DESCRIPTIVE REPORT

Field No WA-HI-10-1-63 Office No. H-8615

REGISTRY NO. H-8615 (1961-63)

Rhode Island, Block Island Sound, Nebraska Shoal to
Ninigret Pond

WIRE DRAG SPEC. PROJ. 1-63
 CHARLESTOWN, R.I.
 WAINWRIGHT & HILGARD
 E.K. McCAFFREY COMDG.
 9 OCTOBER 1963
 Scale 1:10,000

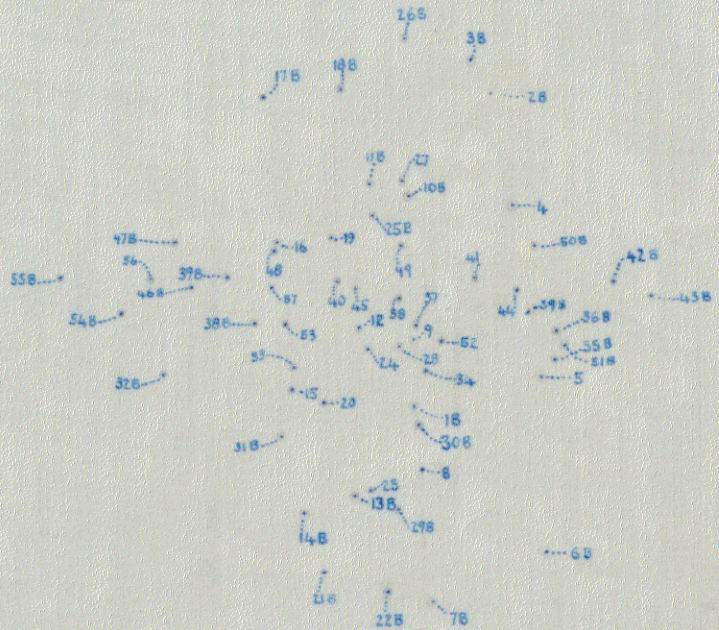
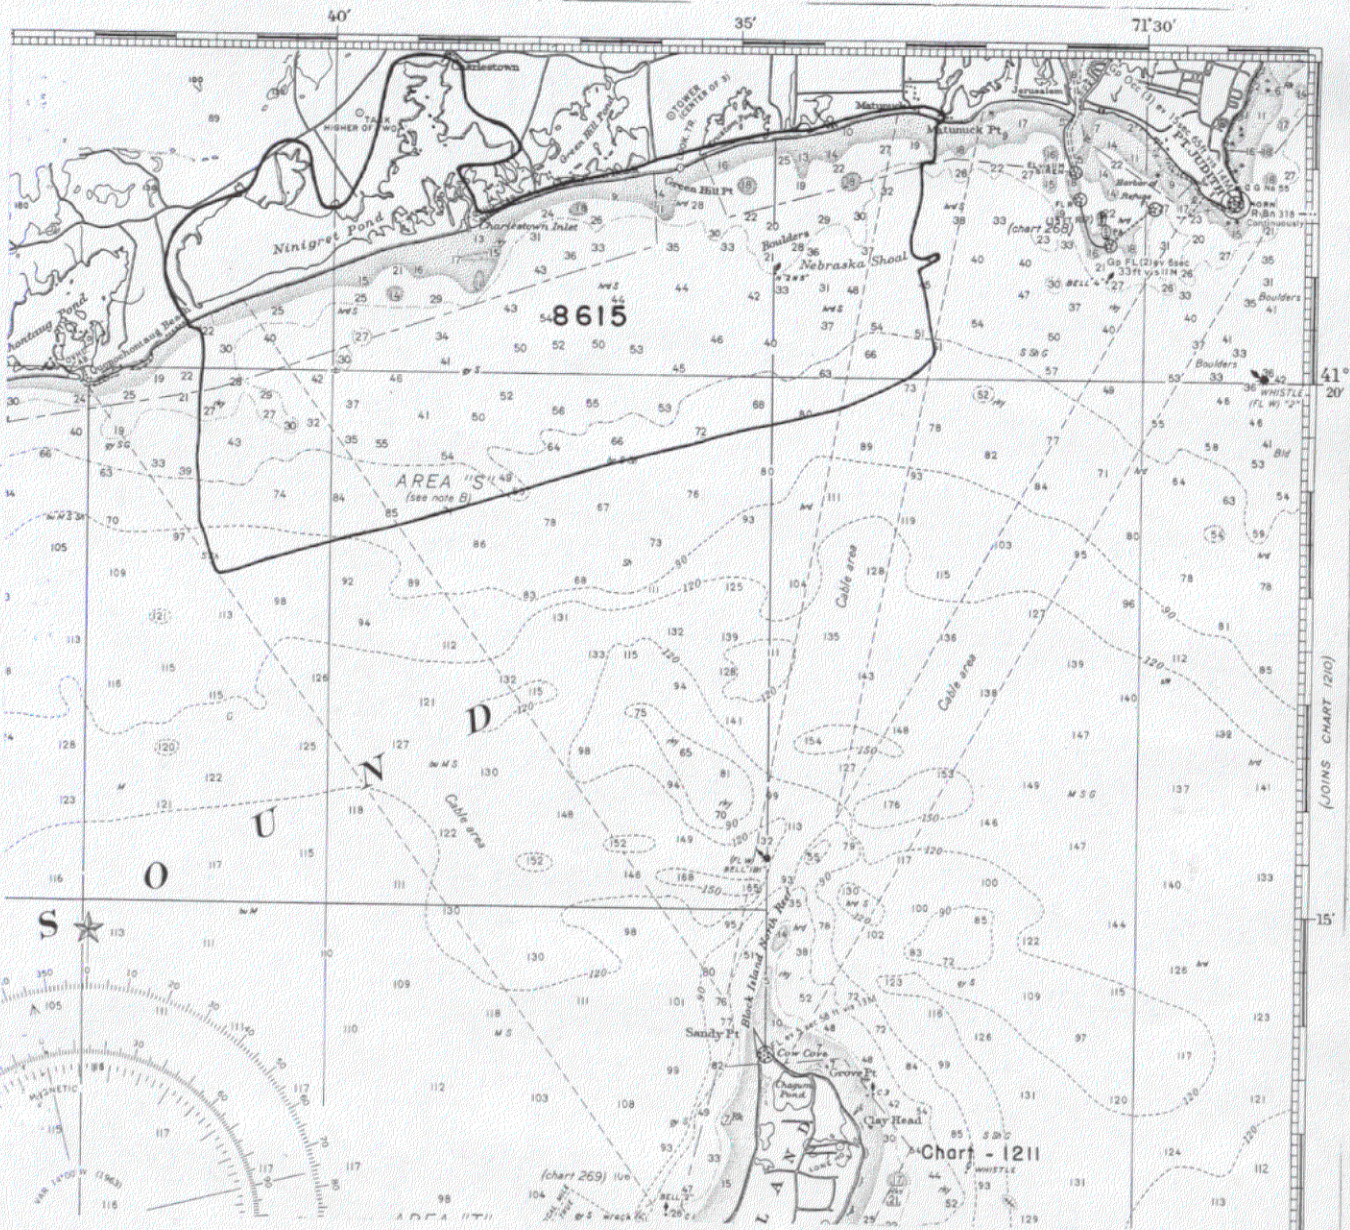
In accordance with supplemental instructions dated Aug. 9, 1963 additional hydrographic and wire drag investigations were carried out in latitude 41° 20.7'N, longitude 71° 39.3'W to verify or disprove the existence of the 14' and 21' soundings shown on contemporary survey WAHI 10-1-61. (*H-8615 [1961-63]*)

An approximate ~~2.0~~ square mile area was wire dragged to an effective depth of 21', in search of the indicated 14' sounding. Although one grounding occurred in latitude 41° 20.67'N, longitude 71° 39.6'W, no investigation was made here as it is on a known shoal. *See attached wire-drag overlay*

No further investigation is deemed necessary and it is recommended that the 14' sounding be removed from the contemporary chart. Not on Chart 1211 (11th Ed. 1/24/66)

The 22-foot cited in the above investigations was ^{not} disproved. It was cleared by wire drag to 21' and a deeper drag was not attempted because of the controlling 25' foot depth in the vicinity of this spot. ✓

Work of 1963
 Selected soundings transferred to
 smooth sheet

No positions plotted on this
 overlay, only sdgs.
